PRELIMINARY DATA REPORT
School Water Supply and Sewage Disposal

SCHOOL Add. Aldie School DATE April 14, 1955
COUNTY OR CITY Loudoun County DIVISION SUPERINTENDENT O. L. Emerick
ARCHITECT Eubank and Caldwell ENROLLMENT: Upon occupancy 200
ADDRESS Roanoke, Virginia Ultimate estimated 250

Re: Add. Aldie School
Loudoun County

SKETCH BELOW WATER SUPPLY, EXISTING AND RECOMMENDED SEWAGE DISPOSAL LAYOUT, AND BUILDINGS

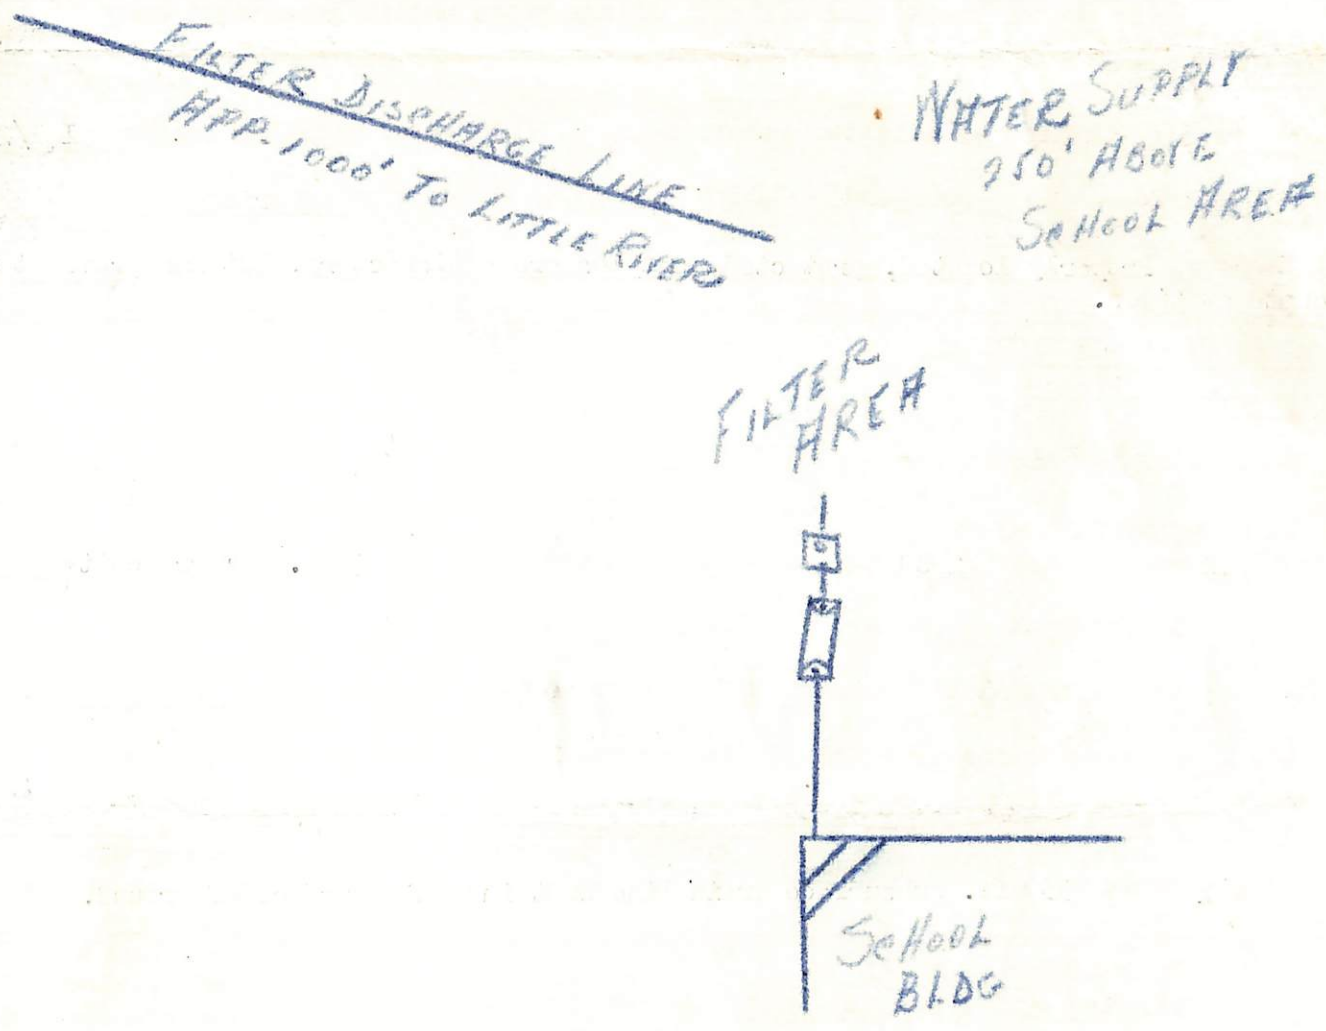
1. Existing system adequate with changes marked in (3) below
2. Existing system to be abandoned. New system outlined in (3) below
3. New individual facilities (Influent line 4 inches
(a) Septic tank of 3000 gallons capacity (Effluent line 4 inches
(b) Dosing tank with 4 inch (single) ~~(twin)~~ siphon
(c) Subsurface drainage field of lines at ft. each, equals total linear ft.

(e) Other facilities 2176 sq. ft. single bed, closed filter, effluent line emptying into Little River.

This being approved for 250 pupils without showers
C.O.B.
